Response to request for review “Kina Biopower 11.5MW EFB Power Plant” project (0385)

We refer to the requests for review raised by four Board members concerning DNV’s request for registration of the “Kina Biopower 11.5MW EFB Power Plant” project (0385).

THE SITE MAP OF KINA BIOPOWER BIOMASS POWER PLANT AND SEGUNTOR BIOENERGY BIOMASS POWER PLANT AT SANDAKAN SABAH MALAYSIA

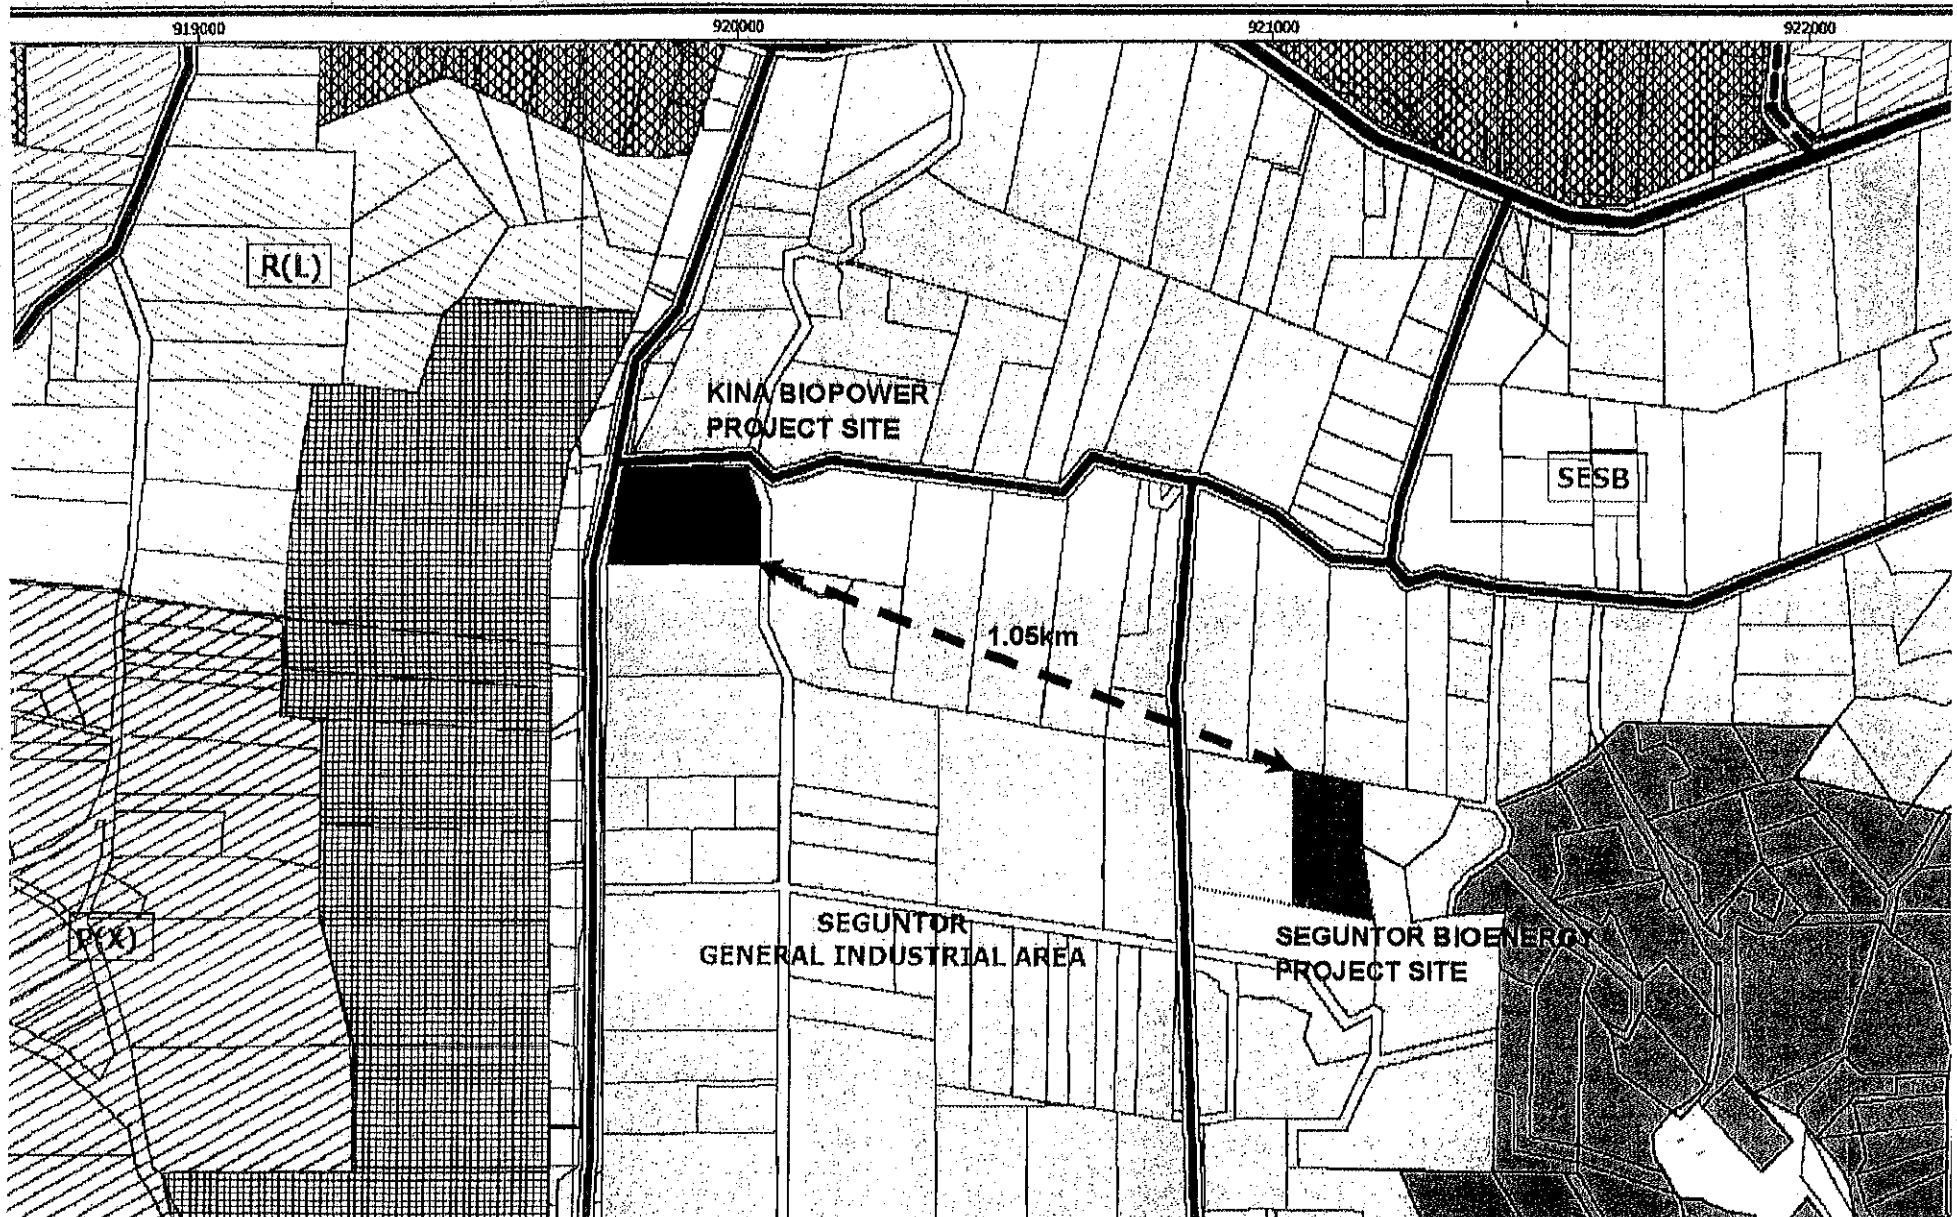
- 1) The Board members noted that the project should have applied version 08 of AMS-I.D and AMS-III.E, which came into effect on 3 March 2006, since the project was submitted for registration on 21 April 2006;
- 2) The Board member request that the validation report should have stated the exact distance between the “Kina Biopower 11.5MW EFB Power Plant” project and the adjacent “Seguntor Bioenergy 11.5MW EFB Power Plant” project in order to justify that the “Kina Biopower 11.5MW EFB Power Plant” project is not a debundled component of the “Seguntor Bioenergy 11.5MW EFB Power Plant” project.

- 2) As shown by the maps enclosed to this letter, the exact distance between the “Kina Biopower 11.5MW EFB Power Plant” project and the “Seguntor Bioenergy 11.5MW EFB Power Plant” project is 1.05 km. The project boundaries of the two projects are thus not within 1 km of each other at the closest point. The two projects are thus not a debundled component of each other in accordance with the Board’s guidance for determining the occurrence of debundling. DNV verified that the distance between the two plants is at least 1 km by driving from one plant to another during the site visit.
